World Shipping Council

Commercial Leasing for Wind Power Development on the Outer Continental Shelf (OCS) Offshore California— Call for Information and Nominations

Docket Number: BOEM-2018-0045

January 28, 2019

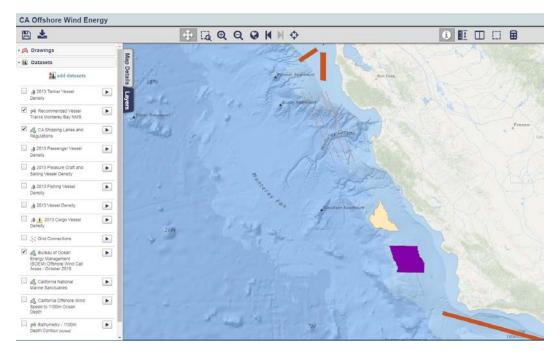
The screen shot below (from the California Offshore Wind Energy Gateway) depicts the Morro Bay and Diablo Canyon call areas, which sit approximately ten nm from one another along the Santa Lucia Bank. Traffic Separation Schemes (TSS) directing traffic into and out of San Francisco Bay and the Ports of Los Angeles and Long Beach are depicted in red. The

Monterey Bay National Marine Sanctuary (MBNMS) recommended vessel tracks are depicted in orange.

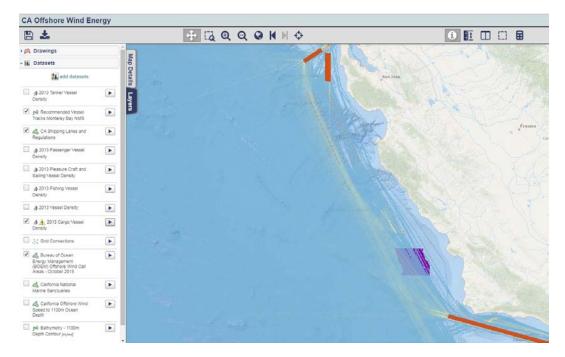
The following screen shot shows the same geographic area with cargo vessel AIS track lines (from 2013). The yellow lines on the picture indicate high-use, longstanding shipping routes used by oceangoing cargo ships operating along the California coast between San Francisco and Los Angeles/Long Beach. Further examination shows that the western halves of the Morro Bay and Diablo Canyon call areas overlap with existing high-use cargo vessel routes.

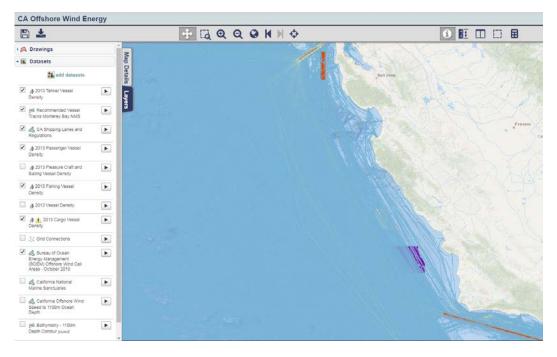
The next screen shot shows the same geographic area, but with AIS track lines for cargo vessels, tankers, passenger vessels, and fishing vessels displayed. The Morro Bay call area is now barely visible and more than half of the Diablo Canyon call area is obscured by the vessel track lines. In simple terms, this indicates that these two proposed wind energy development areas pose direct conflicts with existing commercial vessel traffic routes for the range of commercial vessels that operate in these waters.

If the Morro Bay and Diablo Canyon call areas remain in the locations proposed, the vessels that currently operate in the traffic routes with which those call areas conflict would be forced to move further offshore, where they could create potential navigational safety conflicts with other oceangoing commercial vessels already operating there. For example, coastal tug and barge and fishing vessel traffic, which usually operates closer to shore, would be forced offshore where larger and often faster container ships, vehicle carriers, tankers and passenger ships operate. Increasing the density of vessels using a given area and the mixing of different vessels sizes and types with vastly different maneuvering and operating characteristics increases the risk of vessel collisions.

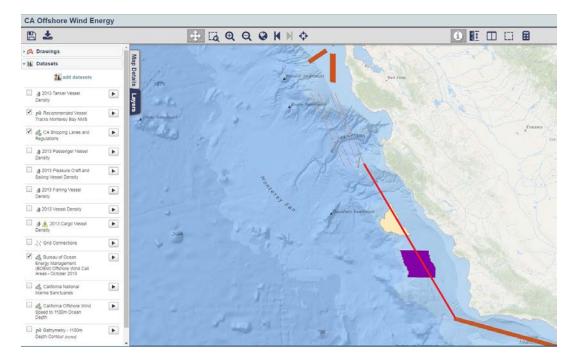
<u>Recommendations</u>: As discussed above, the proposed Morro Bay and Diablo Canyon call areas pose direct and substantial conflicts with the USCG MPG, with existing commercial vessel traffic routes and with vessels following the MBNMS recommended tracks.

- 1) Eliminate from consideration any call area aliquots to the west of a line drawn from the easternmost lane of the MBNMS tracks to the easternmost lane of the Santa Barbara Channel TSS (see red line in chart below); and
- 2) Work with the USCG to complete a navigational safety risk assessment or port access route study (PARS) of the waters between and including the ports of San Francisco and Los Angeles/Long Beach.

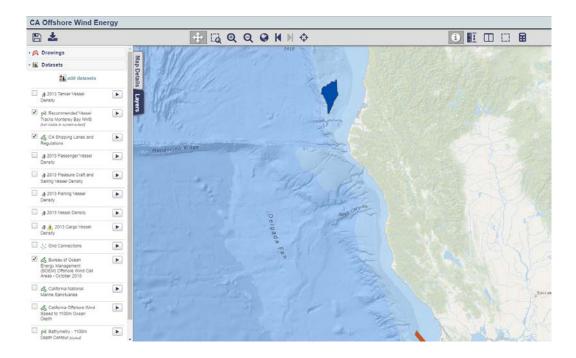
The following screen shot depicts the Humboldt call area. At the lower right corner of the image, the entrance/exit of the northernmost TSS serving San Francisco Bay is visible.

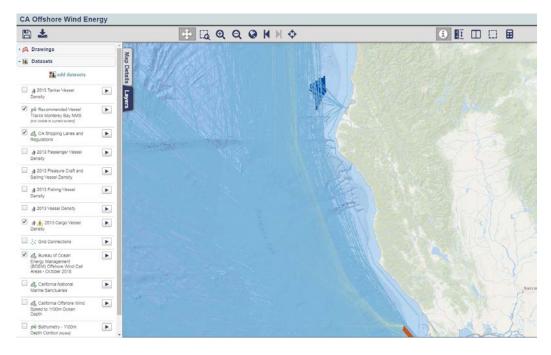
The following screen shot shows the same geographic area with cargo vessel AIS track lines. The yellow lines on the picture just west of the proposed call area indicate high-use, shipping routes used by oceangoing cargo ships operating along the California coast between San Francisco and ports to the north.

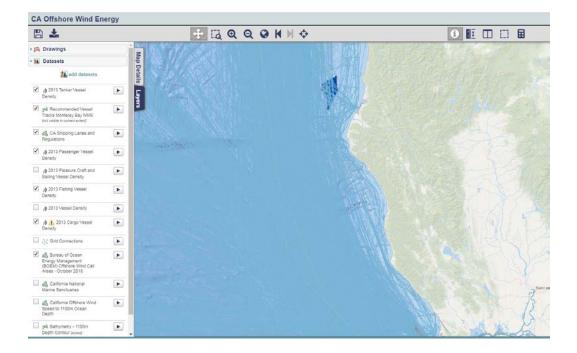
The next screen shot shows the same geographic area, but with AIS track lines for cargo vessels, tankers, passenger vessels, and fishing vessels displayed. When compared with the image above, the image below demonstrates not only that large numbers of vessels of various types are already operating in the proposed Humboldt call area, but also that the presence of a wind farm in the call area would force vessels that normally transit through the call area to divert either offshore or nearer to shore (depth permitting). Diversion of coastal vessels offshore creates potential navigational safety conflicts with larger, faster oceangoing commercial vessels that already operate there. As stated earlier in these comments, increasing the density of vessels using a given area and the mixing of different vessels sizes and types, with vastly different maneuvering and operating characteristics, increases the risk of vessel collisions.

- 1) Eliminate from consideration any call area aliquots to the west of 124.66 degrees west longitude; and
- 2) Work with the USCG to complete a navigational safety risk assessment of the waterways that may be affected by the proposed call area.
